RFP#16-18
FOUNDRY PLACE PARKING
GARAGE PERCENT FOR ART PROJECT
PORTSMOUTH, NH
November 28, 2017

Addendum#1

This Addendum forms part of the original document marked: RFP#16-18 Foundry Place Parking Garage Percent for Art Project.

POTENTIAL ART LOCATIONS
FOUNDRY PLACE PARKING GARAGE
 PORTSMOUTH NH

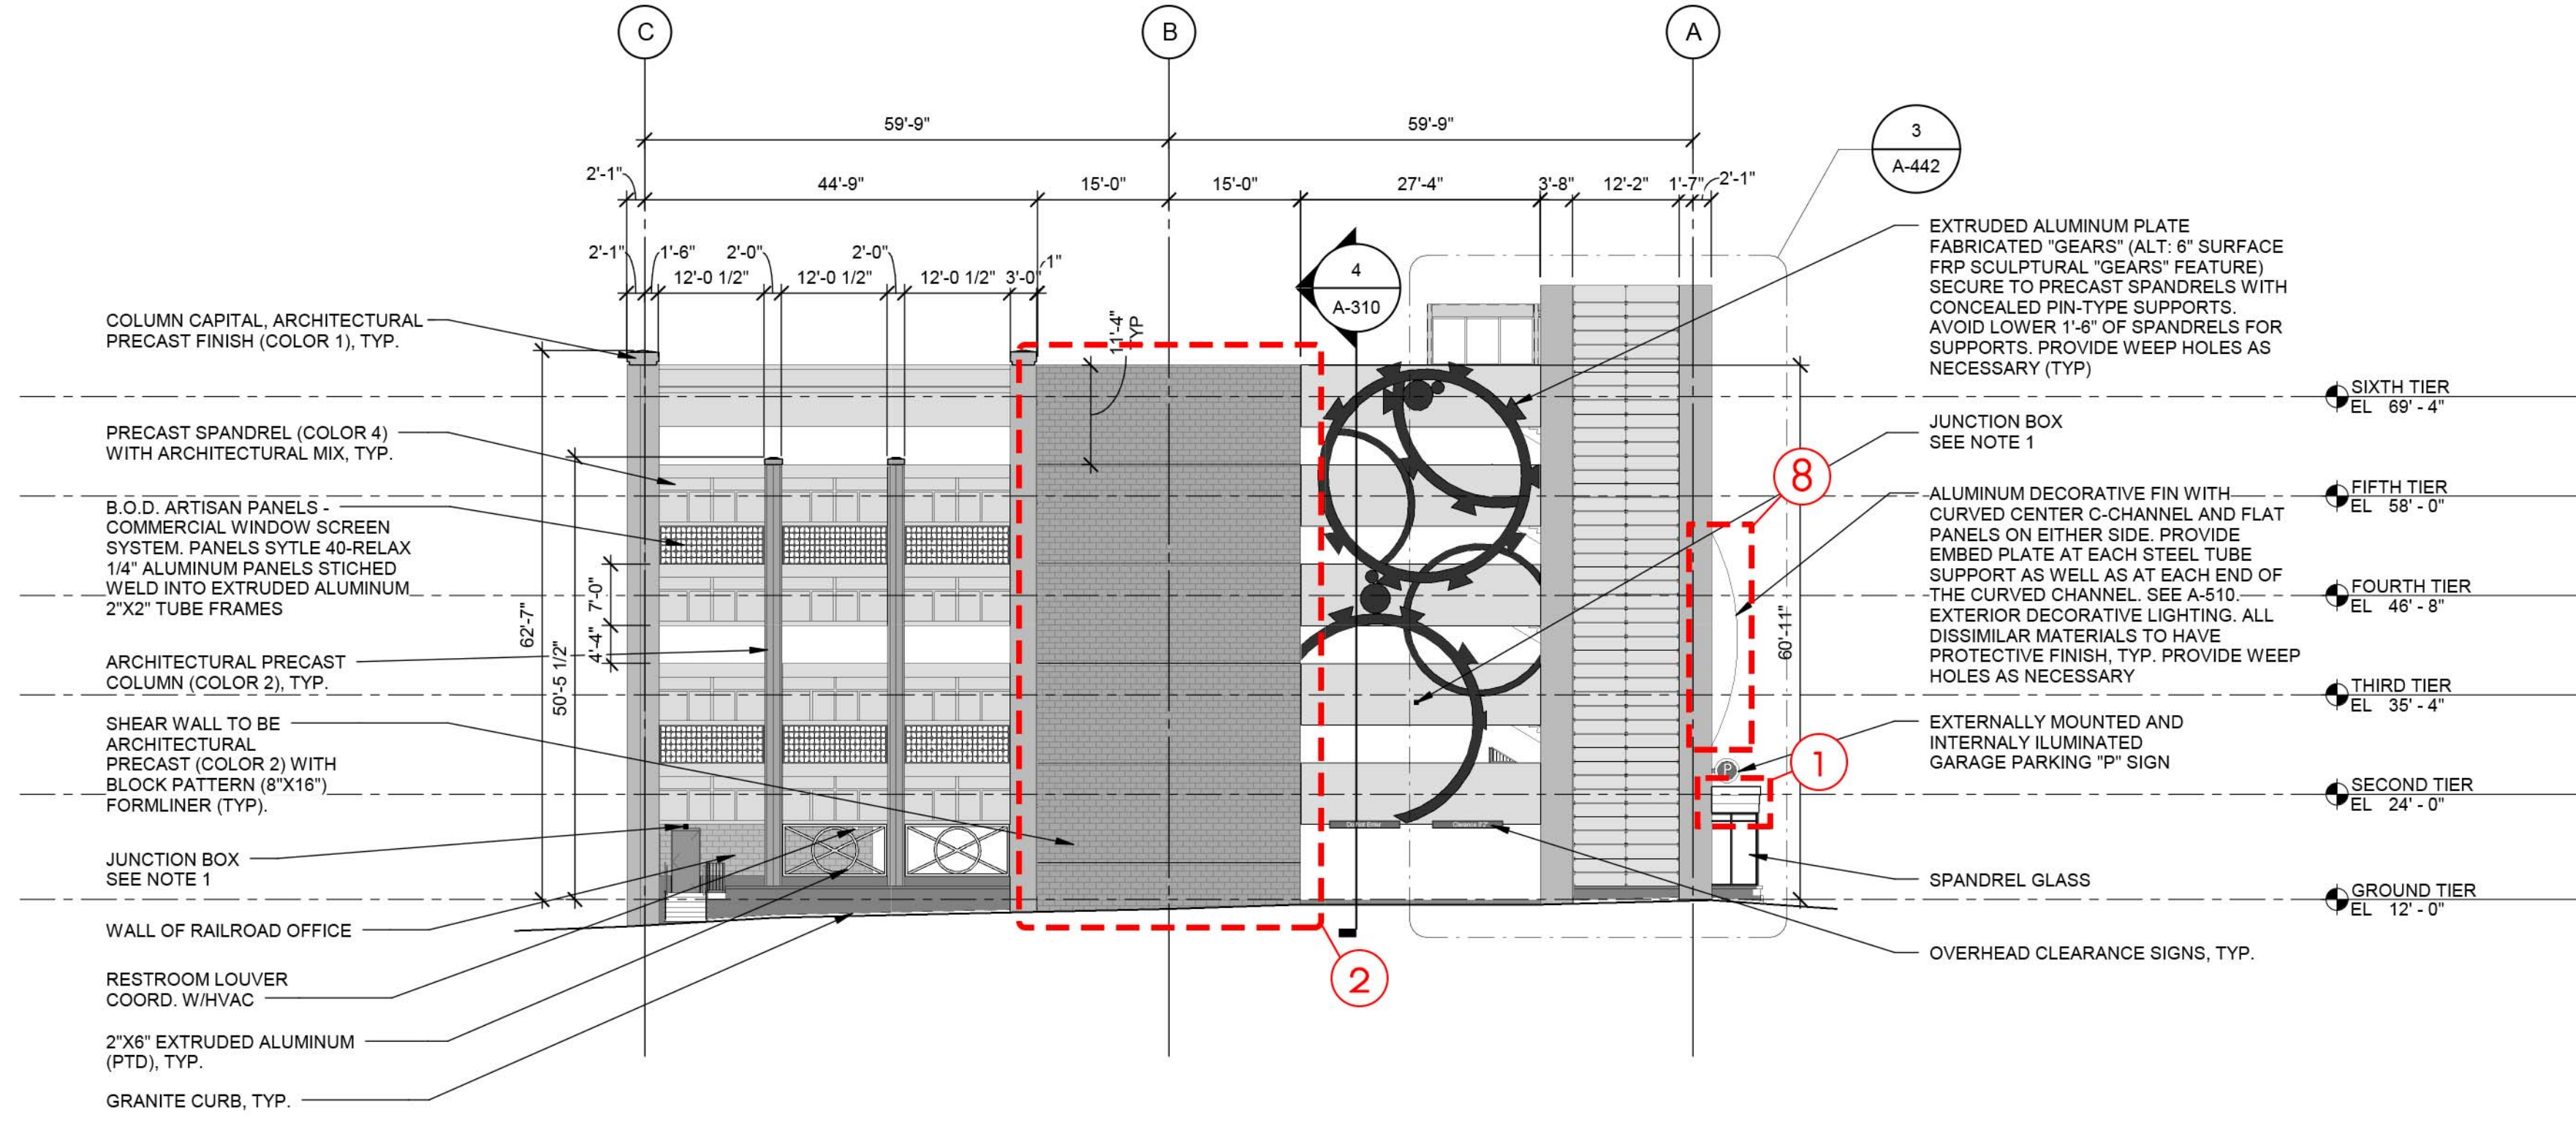
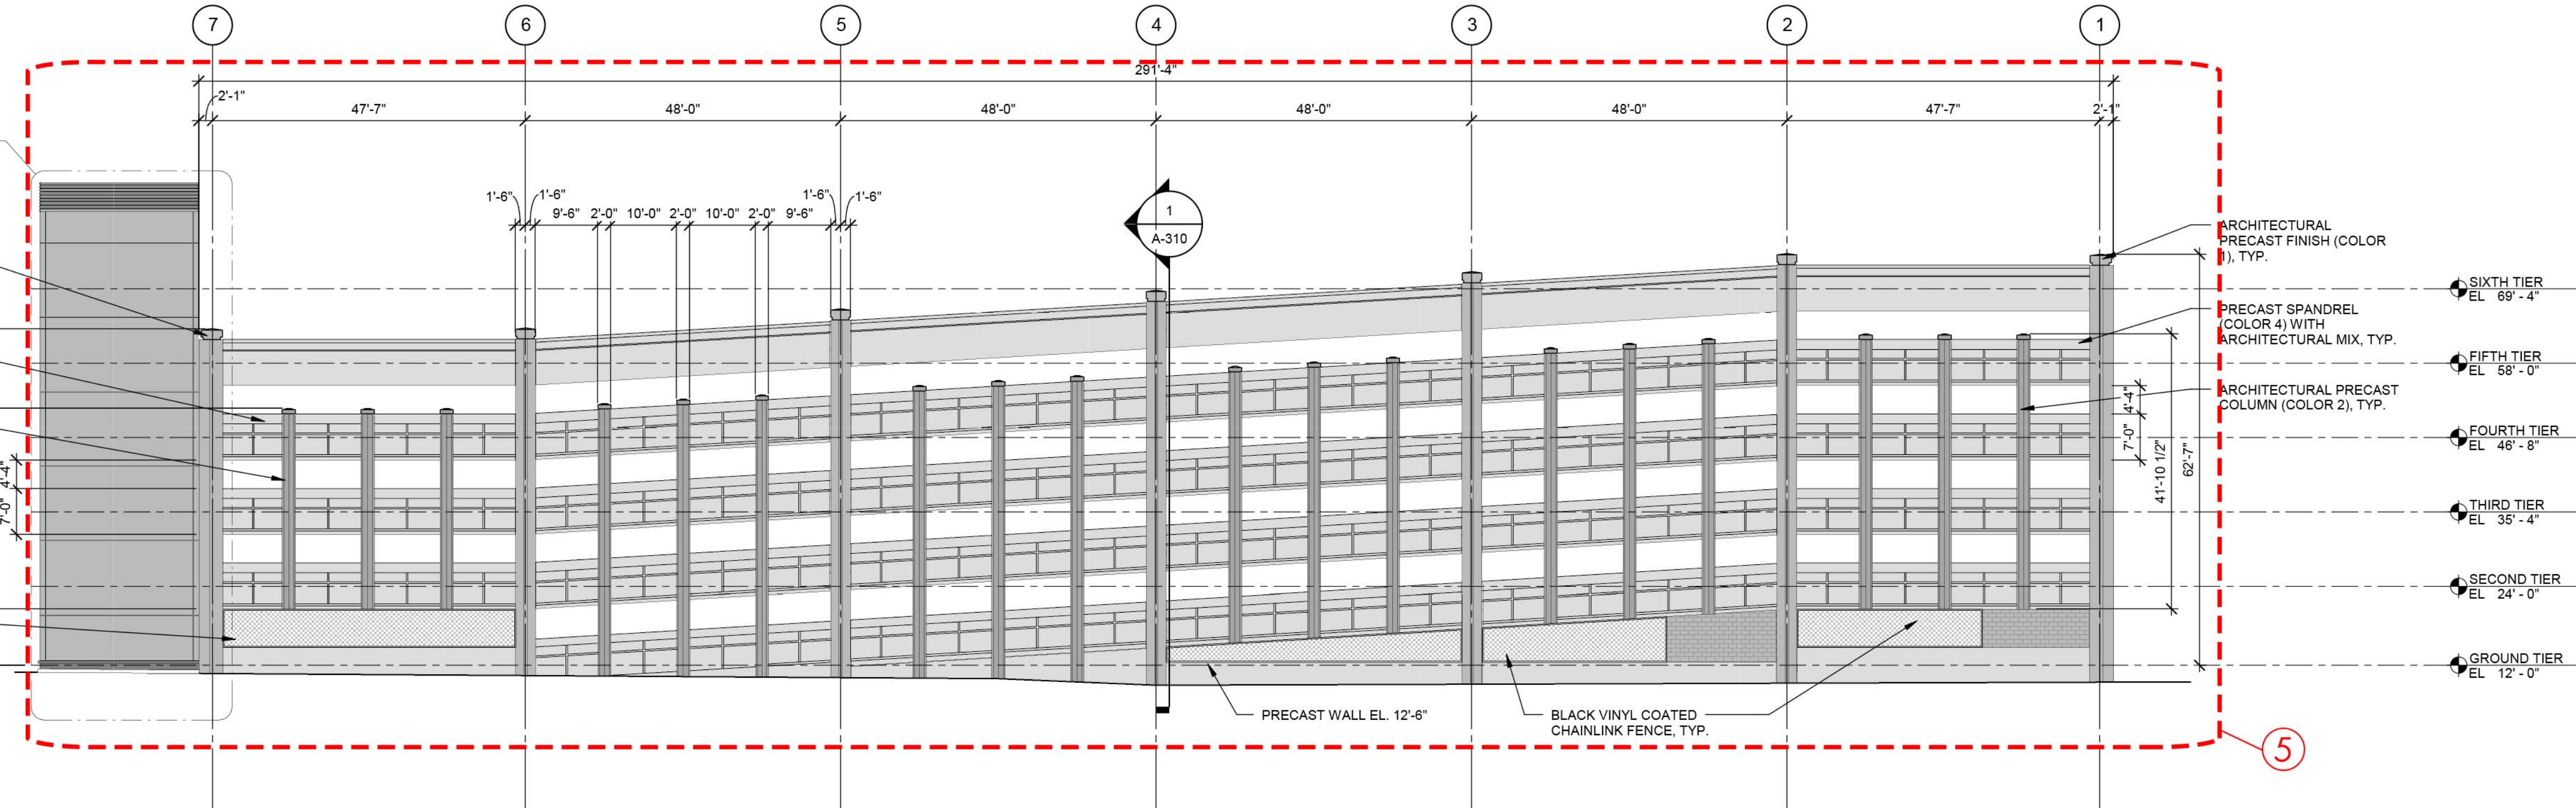
CONSIDERATIONS					
LOCATIONS	ELECTRICITY EASILY AVAILABLE	STRUCTURAL CONSIDERATION	WIND LOAD CONSIDERATION	MOUNTING RESTRICTIONS	COMMENTS
1. TOP OF FLEX SPACE ROOF					
2. SHEAR WALLS					
3. GROUND SURFACE					
4. ROUNDABOUT CENTER					OVERALL DIAMETER OF PROPOSED INSTALLATION MUST NOT INTERFERE W/ FIRETRUCK TURNING RADIUS.
5. ENTIRE ELEVATION					SHOULD NOT PROJECT MORE THAN 4" FROM BUILDING FACE.
6. STAIR TOWER (INTERIOR)					
7. TOWER TOPS					
8. FIN SURFACE					
9. ELEVATOR SURFACE (INT.)					MINIMAL IMPACT ALLOWED PER FIRE DEPT. & STATE ELEVATOR INSPECTOR GUIDELINES. GRAPHIC ONLY.
10. LIGHT WALL (INT.)					
11. BACKSIDE OF FLEX SPACE (INT.)					
12. UPPER WALL SURFACE OF TOWERS (INT.)					
13. STAIR B LANDING WALLS (INT.)					
14. PORTSMOUTH LETTER LOCATIONS					REQUIRES HIGH LEVEL OF COORDINATIONS FOR MOUNTING LARGE INSTALLATION.
